**METROPOLITAN GOVERNMENT OF NASHVILLE AND DAVIDSON COUNTY**

**STAFF RECOMMENDATION**  
**1505 & 1507 Holly Street**  
**October 15, 2014**

**Application:** Preliminary review of Specific Plan (SP)  
**District:** Lockeland Springs-East End Neighborhood Conservation Zoning Overlay  
**Council District:** 06  
**Map and Parcel Number:** 08309045300, 08309045400  
**Applicant:** Rich McCoy, rem3studio@att.net  
**Project Lead:** Paul Hoffman, paul.hoffman@nashville.gov

SITE PLAN

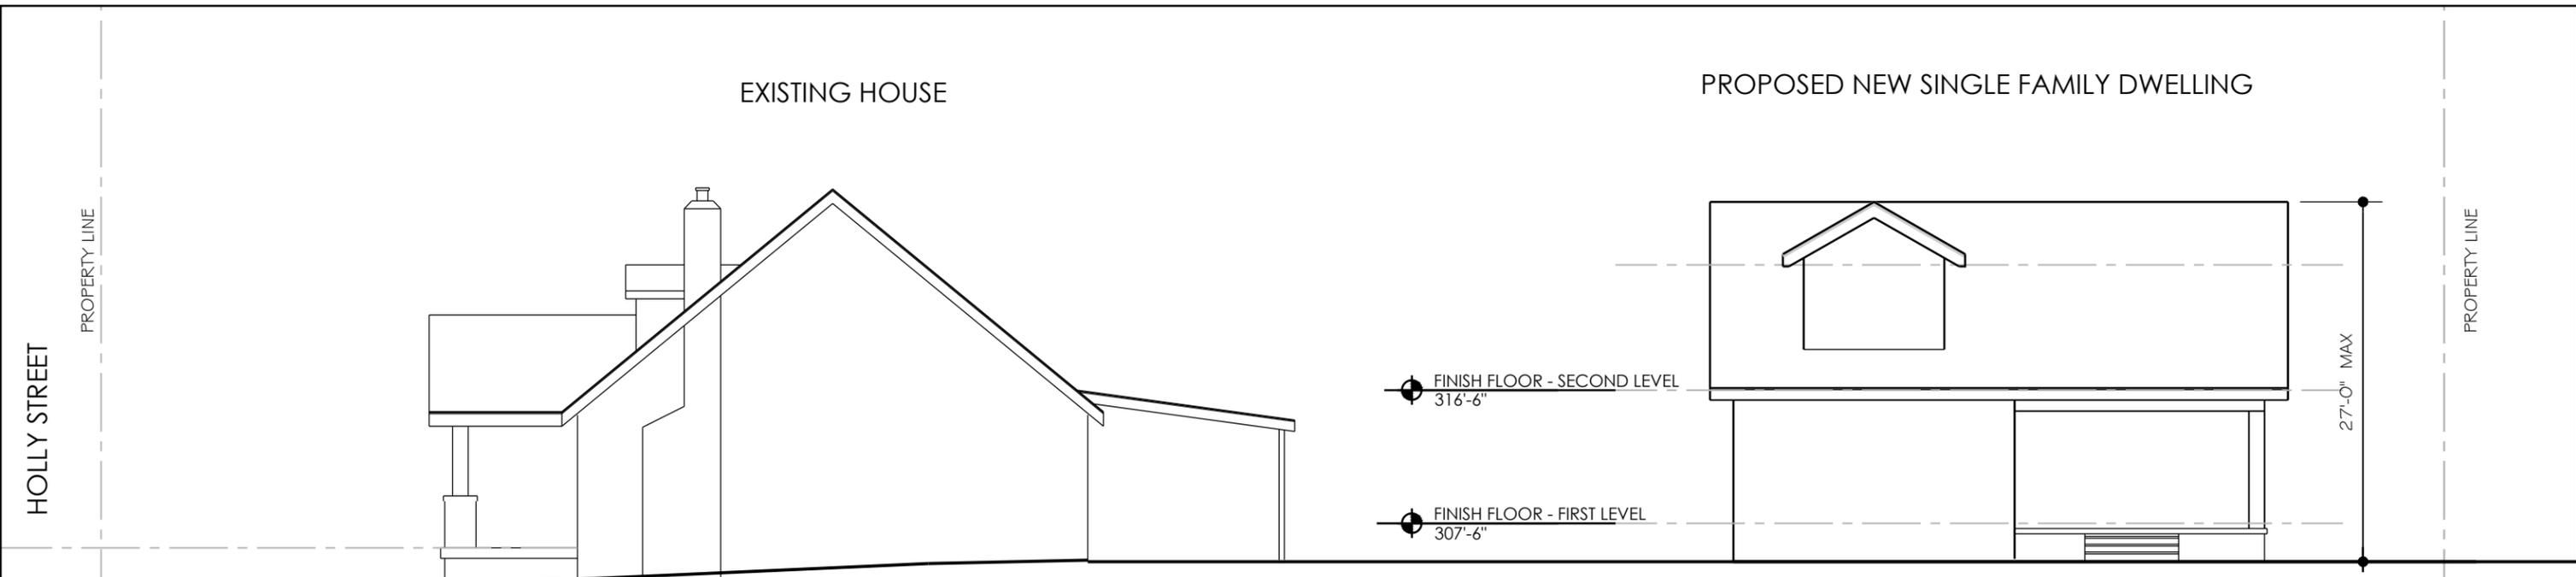
Setback & Rhythm of Spacing: The proposed front setback is sixteen feet (16'). The front setbacks of the buildings across Lindsley Park Drive vary from approximately thirty-four feet to fifty-five feet (34'-55') due to the curve of the street. On the same side of the street, the setbacks are quite shallow, approximately twelve to eighteen feet (12' - 18'), again due to the curve of the street creating shorter than typical lots. The proposed house will be approximately five feet (5') and eleven feet, six inches (11'6") from the side property lines of the new lot. The rear setback will be twenty-five feet (25'). The proposed setbacks meet base zoning requirements, and the project meets section II.B.3.

Orientation: The proposed new house will face Lindsley Park Drive with a front porch and a walkway leading to the street. A new driveway is proposed for vehicular access at the rear of the current lot with a covered deck providing two parking spaces. Generally the Commission does not approve new curb cuts; however, there is no alley access to this lot. An existing parking area behind 1507 Holly Street is the site of the proposed new building. 1507 will have street parking; the duplex at 1505 has a driveway. The project meets section II.B.6.

Staff recommends approval of the proposed Specific Plan (SP), finding that the project meets the applicable sections of II.B of the design guidelines for the Lockeland Springs-East End Neighborhood Conservation Zoning Overlay.

ELEVATIONS

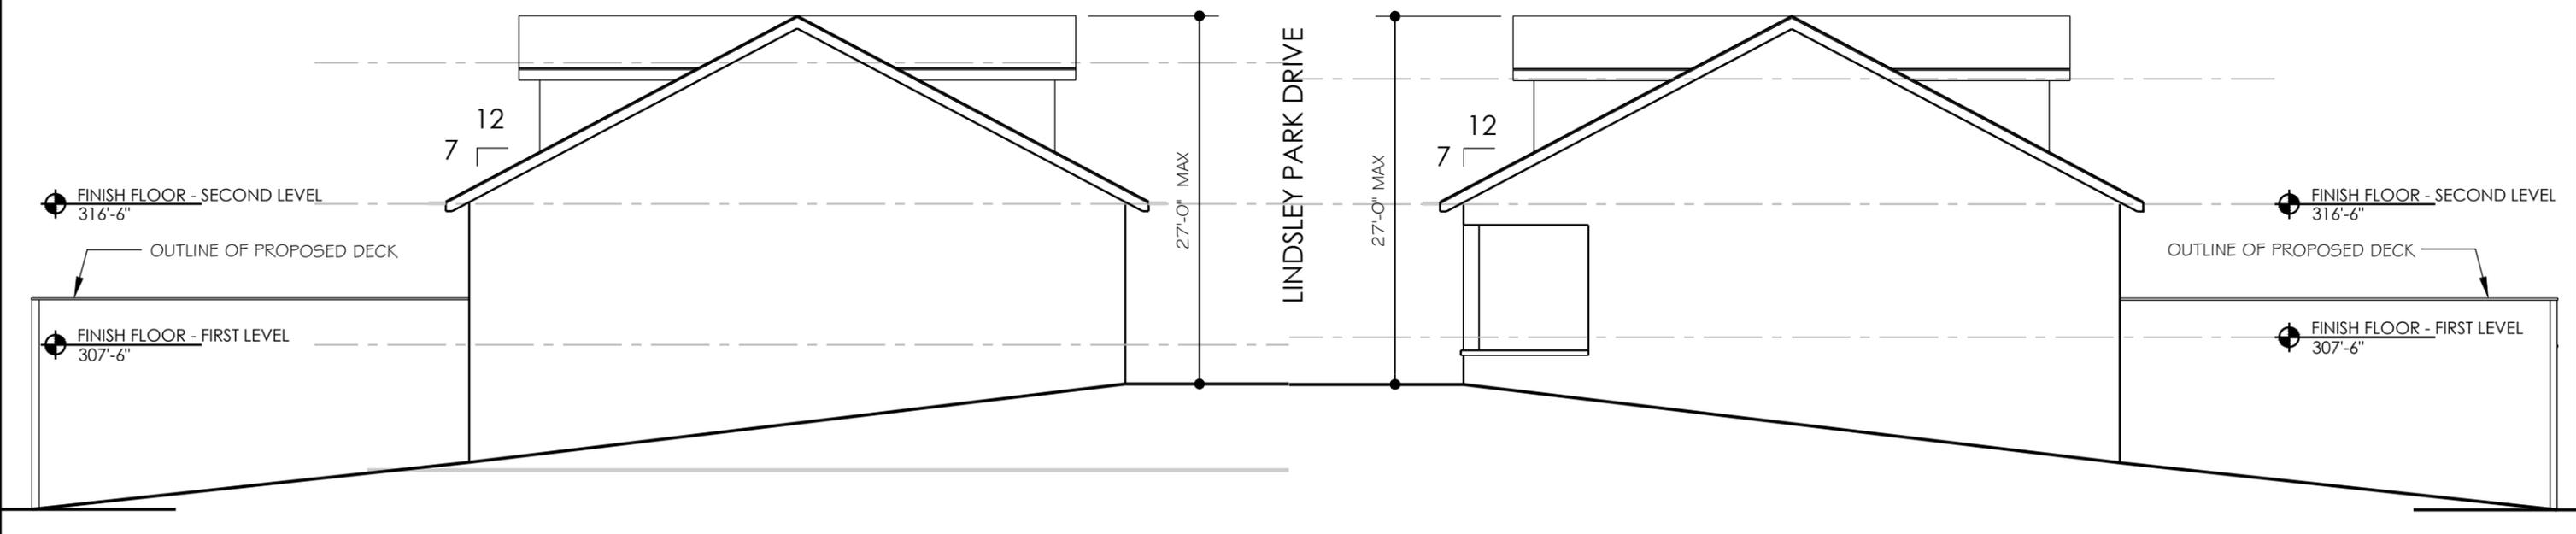
Height & Scale: The proposed building will be forty-two feet by thirty-four feet (42'x34') for a total footprint of one thousand, four hundred and twenty-eight square feet (1,428 sq. ft.). The proposed width of thirty-four feet (34') is compatible with the buildings nearby, which are as wide as forty feet (40'). The building's height will vary from twenty-one feet (21') to twenty-seven feet (27') from grade, due to the slope of the site. This is also within the range of homes on Holly Street, Woodland Street and Lindsley Park Drive, which range from eighteen feet (18') up to thirty-three feet (33'). Being on the smaller end of these height and width ranges, is also appropriate, as the lot is not as large as the standard lot in the neighborhood. The proposed foundation height of two feet (2') is within the range of what is found on contributing buildings in the district, from one to three feet (1'-3'). The eave height is drawn at ten feet (10'), which is also appropriate. The project meets section II.B.1.and 2.

Roof form: The proposed roof is a side gable with 7/12 pitch. The dormers on the elevations are compatible with surrounding contributing buildings. The project meets section II.B.5.
